NPDES Compliance Inspection Report

**Rick Franklin Corporation
Lebanon, Oregon**

Permit #: ORR607180

Inspection Date: December 17, 2021

Site Diagrams Provided by Facility

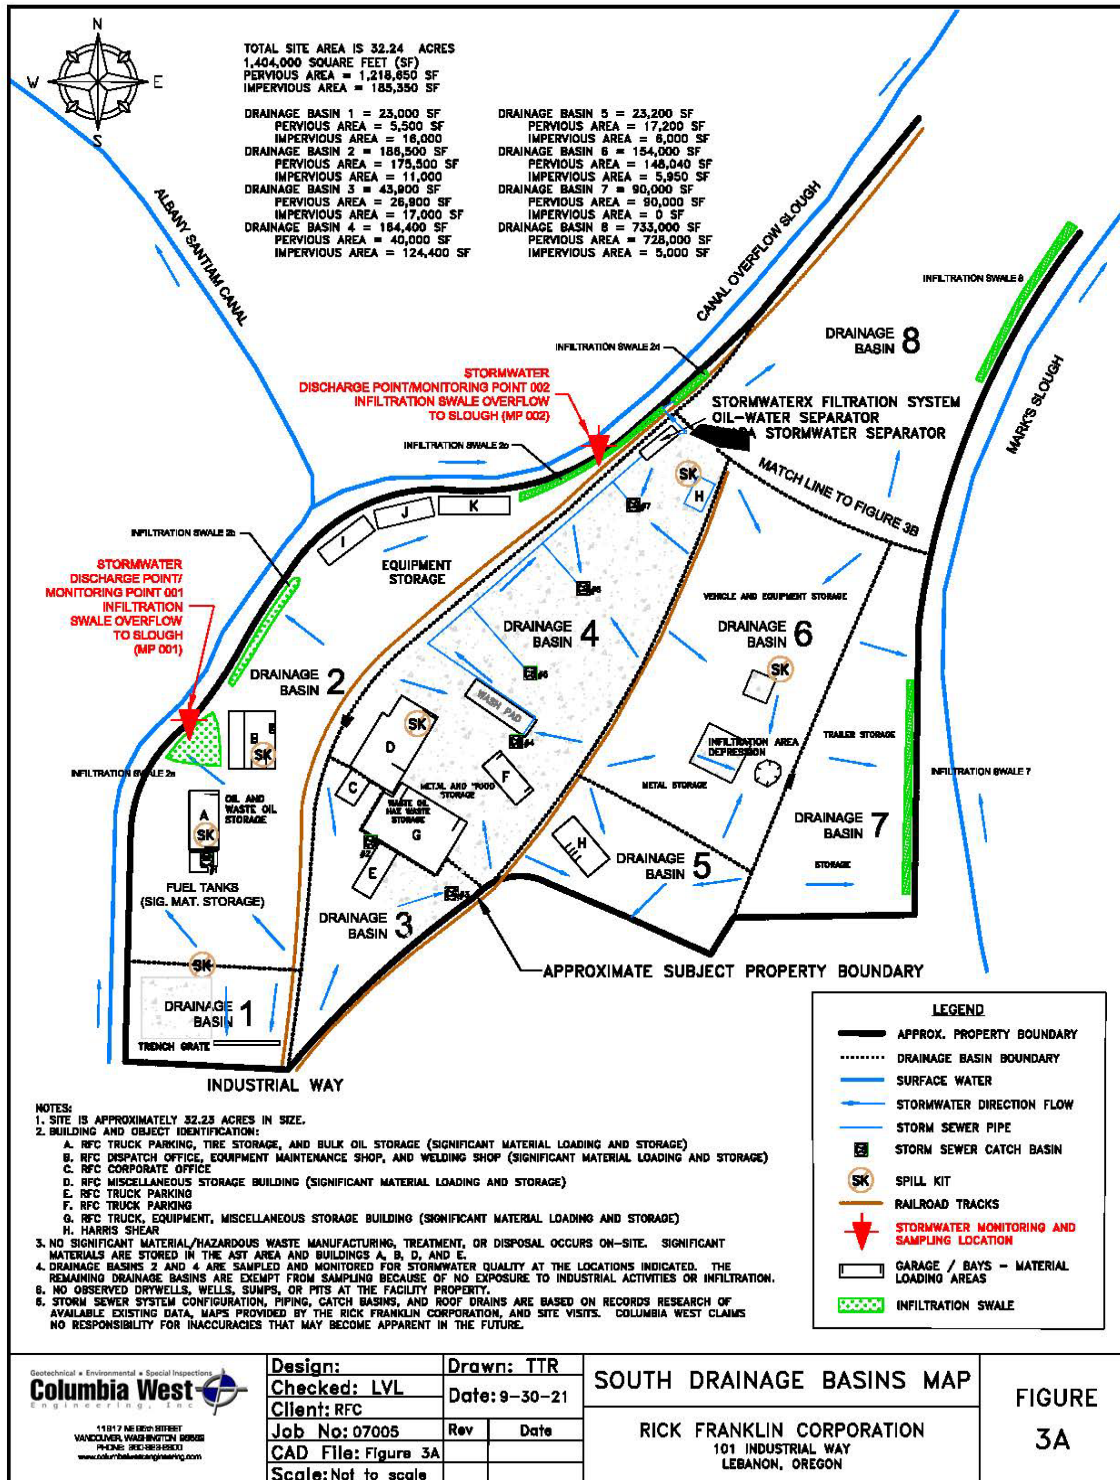
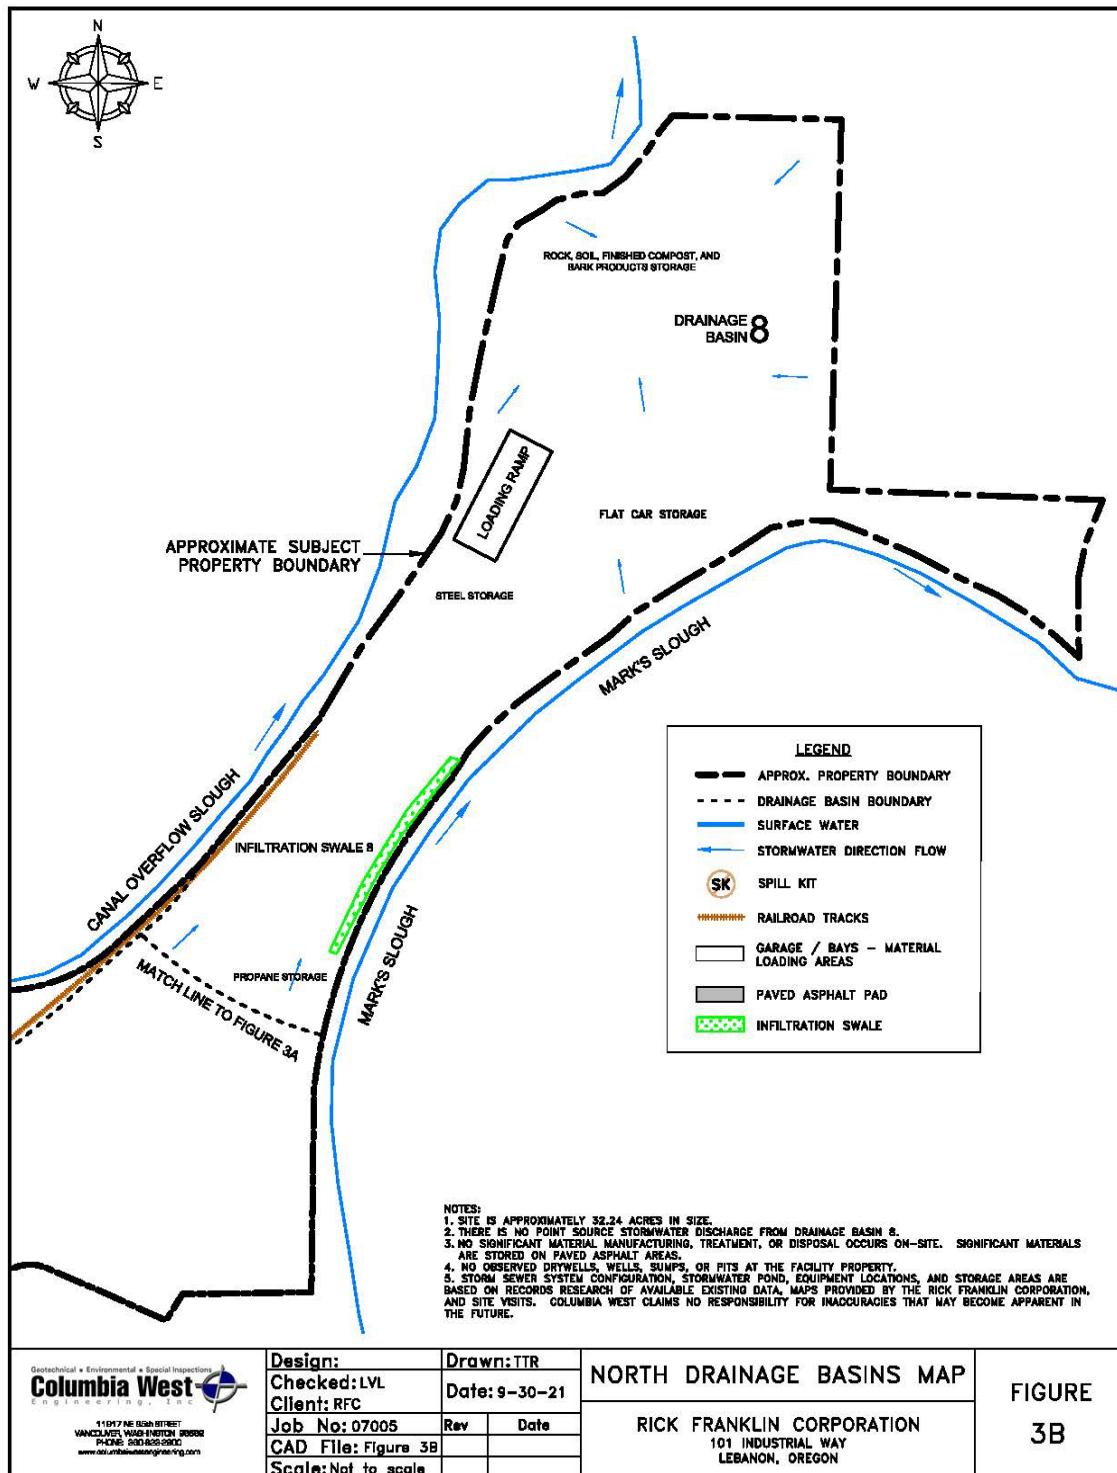
The site map shows three buildings, labeled I, J, and K, positioned end-to-end. The labels were not identified at the bottom of the map in number two of "Notes" as other structures had been identified.
